MANATEE COUNTY, FL
FORT HAMER ROAD PHASE II
US 301 TO FUTURE FORT HAMER BRIDGE
323-6054764

MANATEE COUNTY, FL
US 301 TO FUTURE FORT HAMER
BRIDGE
COVER SHEET

UPPER MANATEE RIVER ROAD ROADWAY FUNCTIONAL IMPROVEMENTS

③ ADDENDUM 3

FORT HAMER ROAD
US 301 TO FUTURE FORT HAMER
BRIDGE
PLAN & PROFILE STA. 108+50 TO 114+00

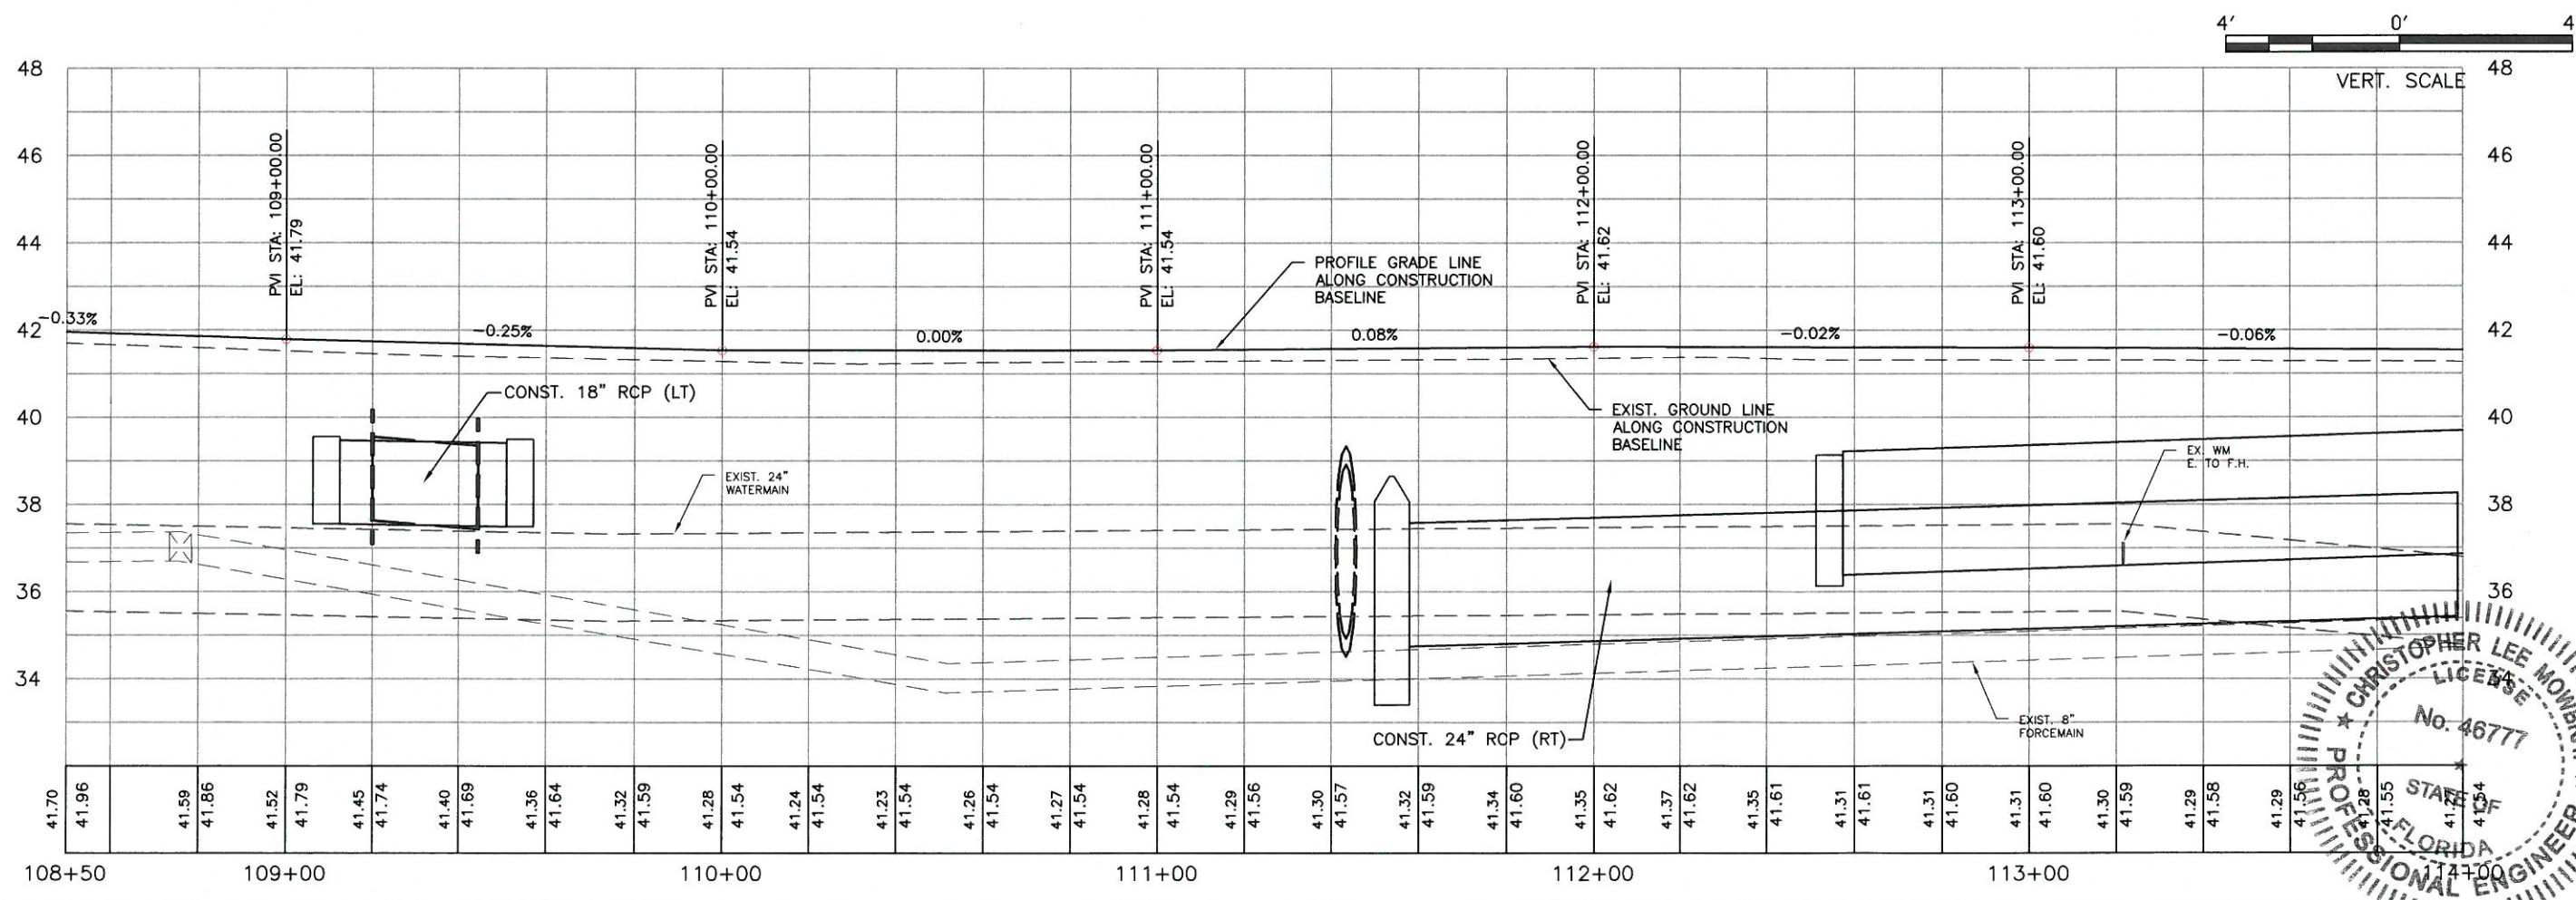
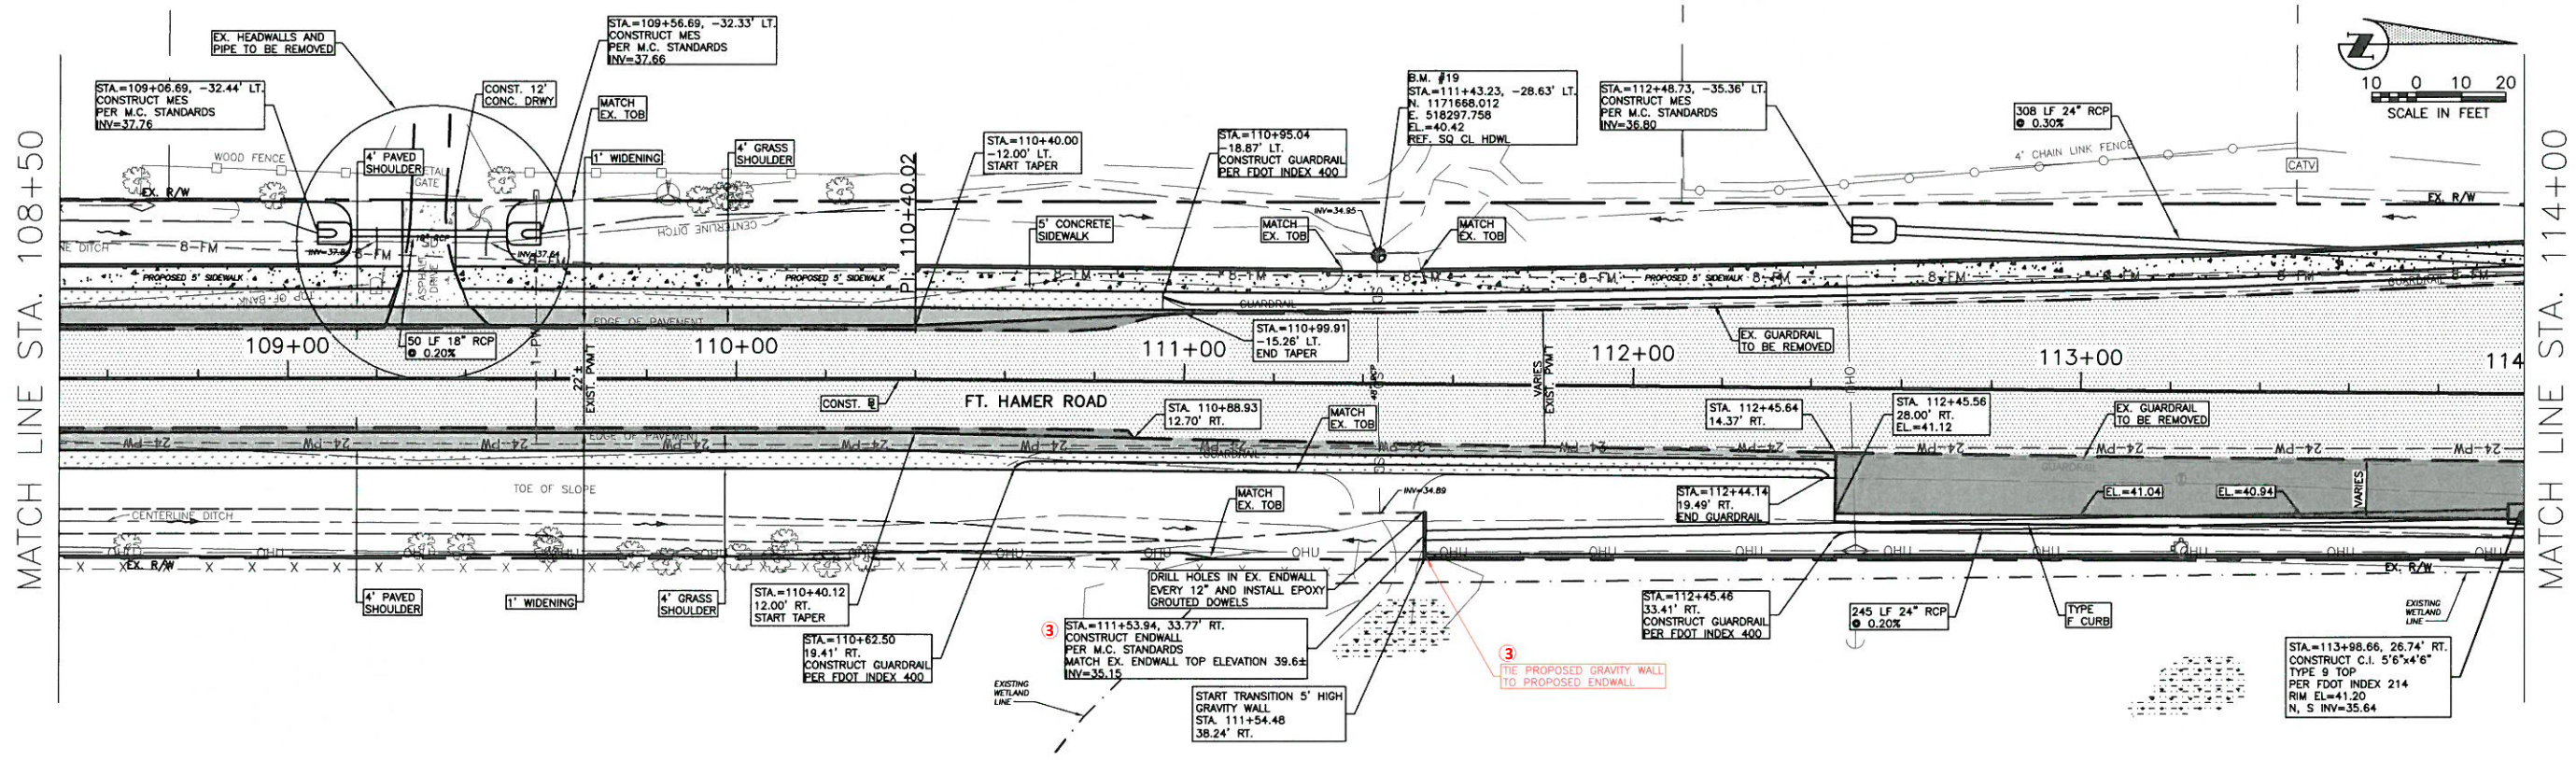
NO.	REVISION DESCRIPTION	BY	DATE
3	EXTENDED 5' GRAVITY WALL TO ENDWALL STA. 111+53.94 RT.		
PROJECT #	323-6054764		
SURVEY #	6982		
SEC./TWN./RGE	7/35S/18E		
SCALE	AS NOTED		
SURVEYED	ZNS	00/00/00	
DESIGNED	AAM	09/2013	
DRAWN	TMF/GB	09/2013	
CHECKED	JP/GB	09/2014	
CHRIS L. MOWBRAY, P.E.			
FLORIDA P.E. # 46777			
Signature & Date			
SHEET	28

**FORT HAMER ROAD PHASE II US
301 TO FUTURE FORT HAMER
BRIDGE
CROSS SECTIONS
STA 111+00 TO STA 112+50**

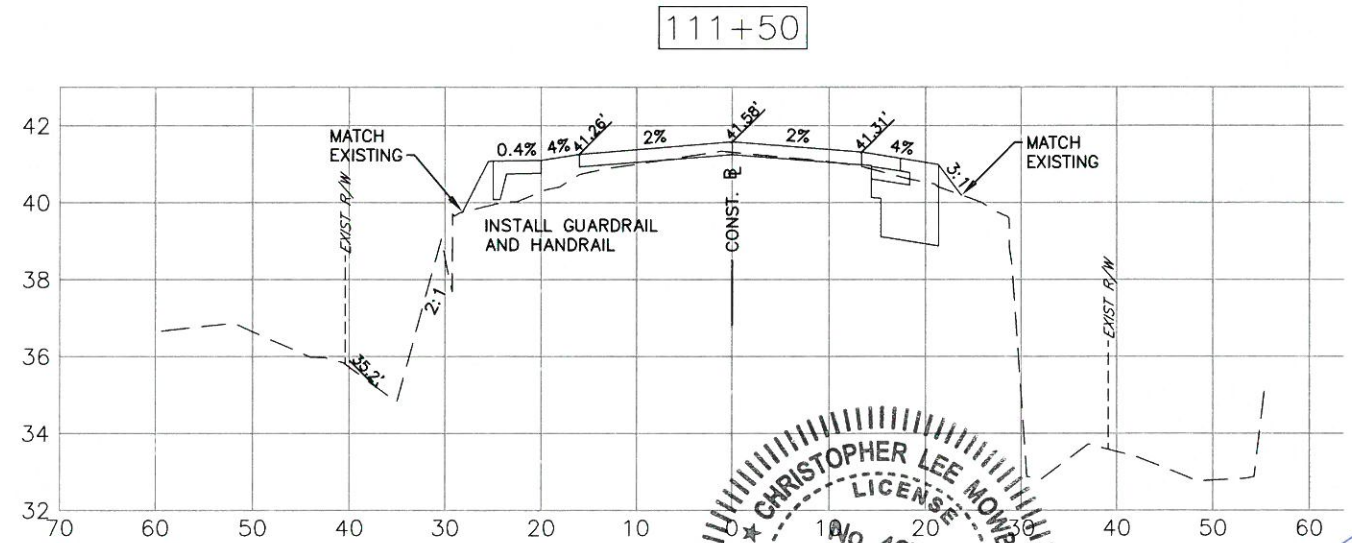
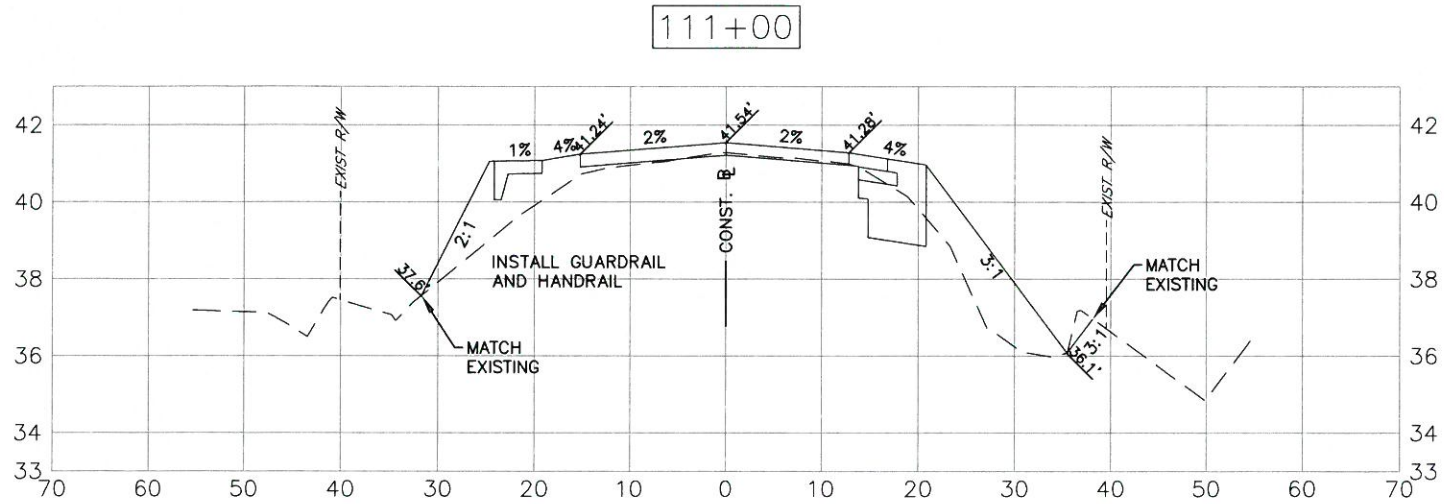
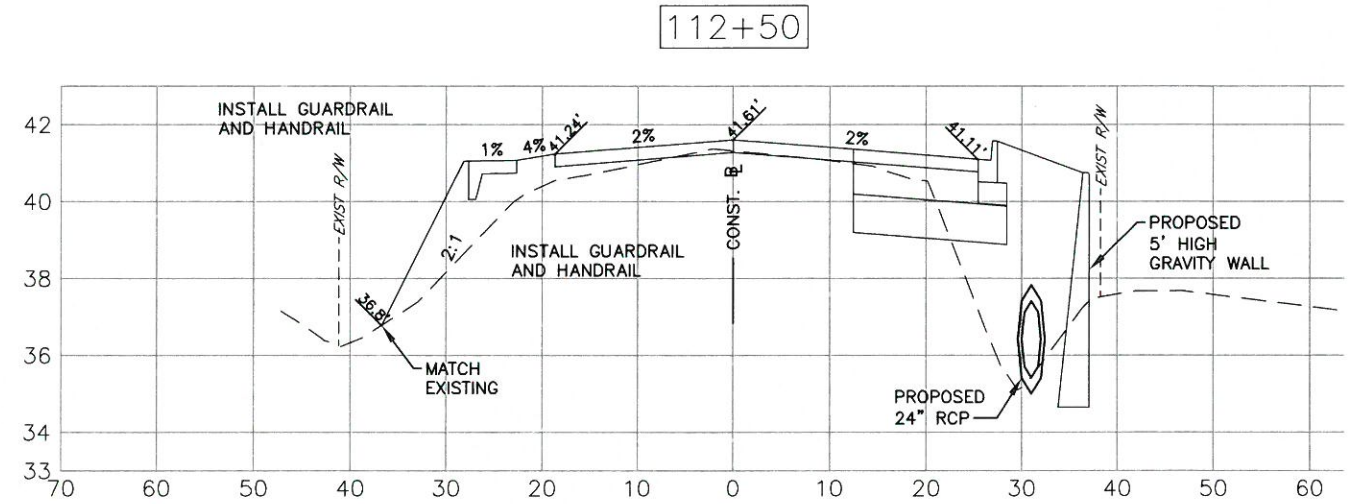
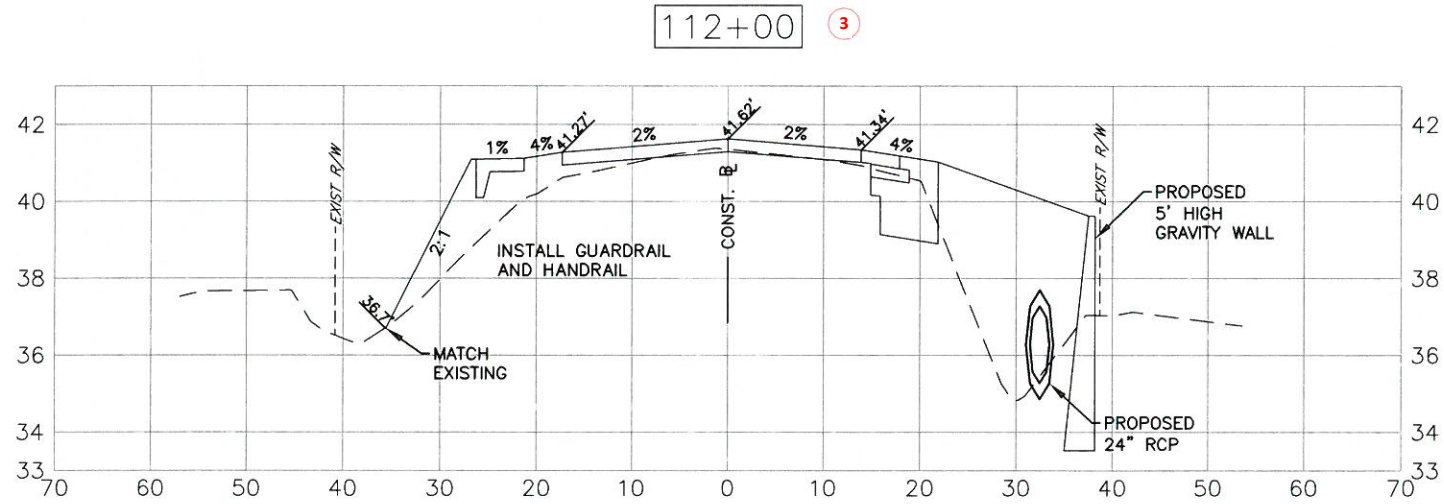
REVISION	DESCRIPTION	BY	DATE
3	EXTENDED 5' GRAVITY WALL TO ENDWALL STA. 111+53.94 RT		
NO.	3		
PROJECT #	323-6054764		
SURVEY #	5303		
SEC./TWN./RGE	7/35S/18E		
SCALE	H=1:20, V=1:5		
SURVEYED	ZNS	BY	DATE
DESIGNED	AAM	01/11/13	
DRAWN	TMF	01/11/13	
CHECKED	JP/GB	09/2014	
CHRIS L. MOWBRAY, P.E. FLORIDA P.E. # 46777			
Signature & Date			
SHEET 70

UPPER MANATEE RIVER ROAD
ROADWAY FUNCTIONAL
IMPROVEMENTS
PLAN & PROFILE STA. 46+40 TO 51+40

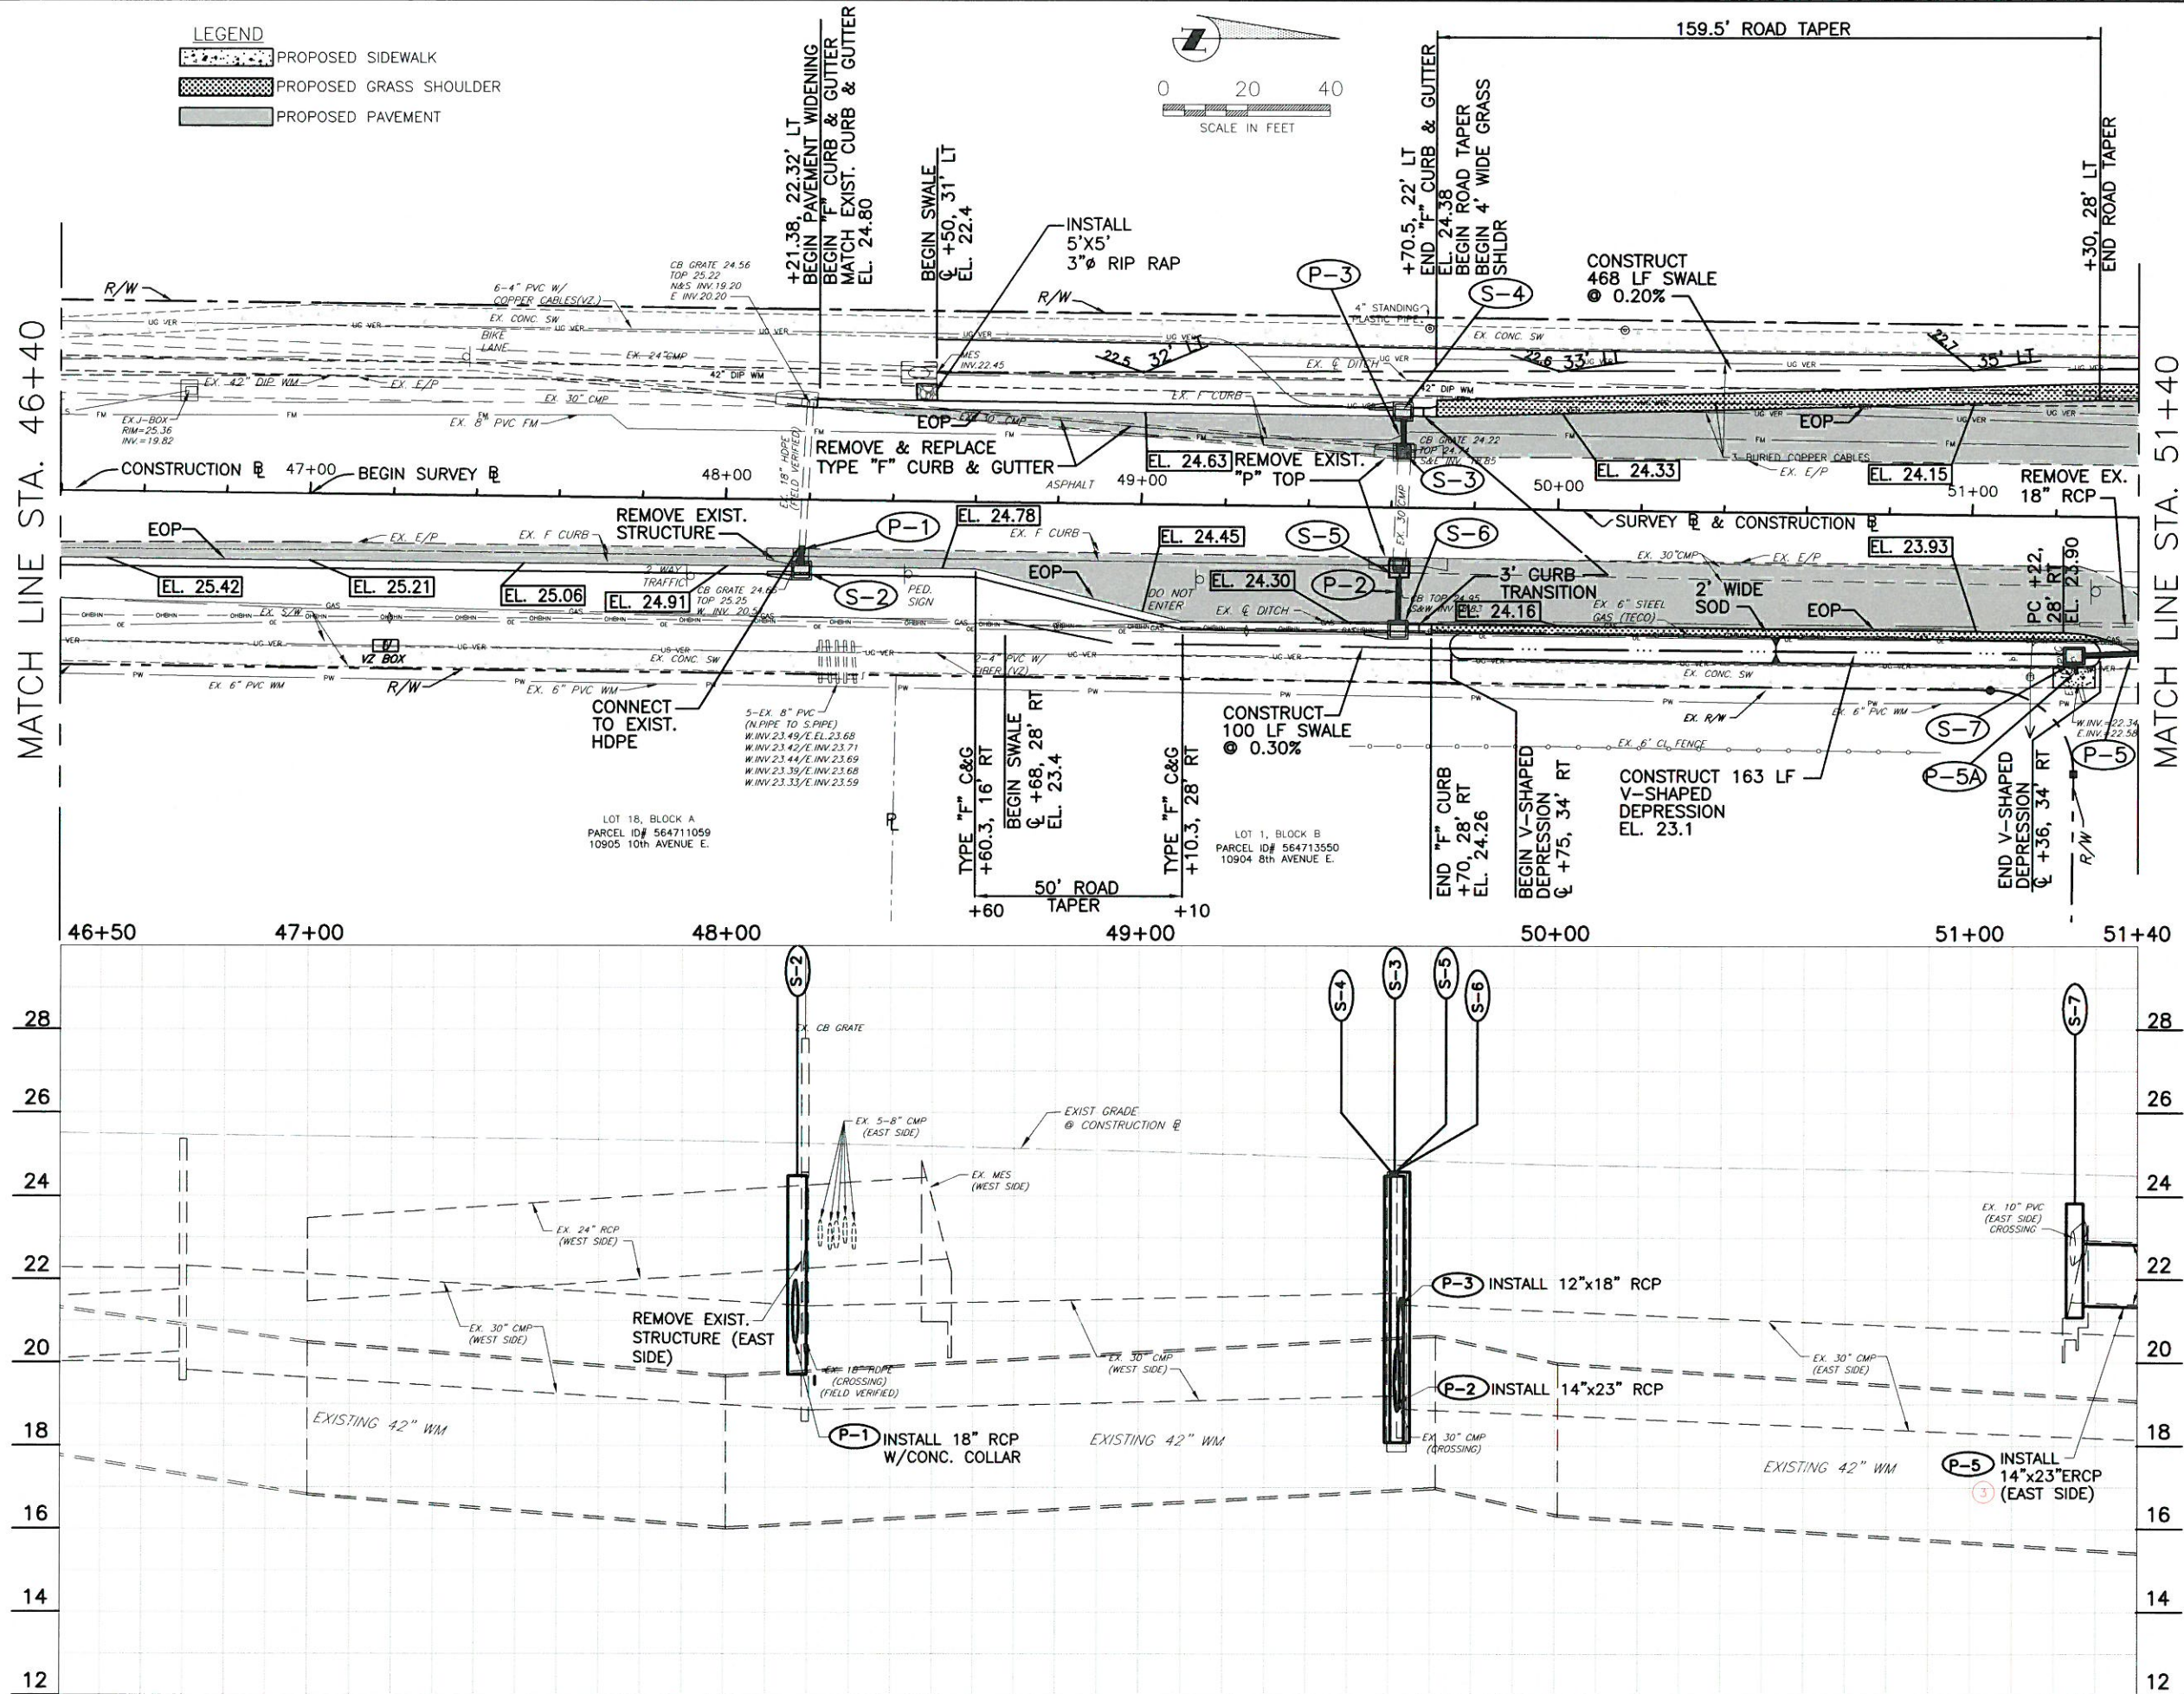
DATE									
BY									
REVISION DESCRIPTION	CHANGED PIPE TYPE FROM RCP TO ERCP ON P-5								
NO.	3								
PROJECT #	307-6082660								
SURVEY #					FILE 00-42783				
SEC./TWN./RGE					19-20, 29-30,34S/19E				
SCALE					1"=40' HORIZ. 1"=4' VERT.				
				BY	DATE				
SURVEYED	ZNS		P4/27/12						
DESIGNED	JG/PBF		06/20/12						
DRAWN	RR/06		06/20/12						
CHECKED	JP/PBF		06/20/12						
CHRISTOPHER L. MOWERS, P.E. FLORIDA P.E. # 46777									
Signature _____ Date _____									
SHEET 17

FIRE HYDRANT BLOW-OFF ASSEMBLY

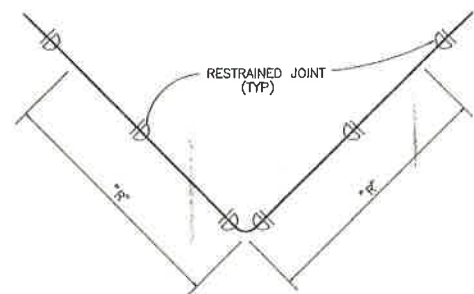
DELETED
AT PRE-CONST.
MEETING ON
6/14/94
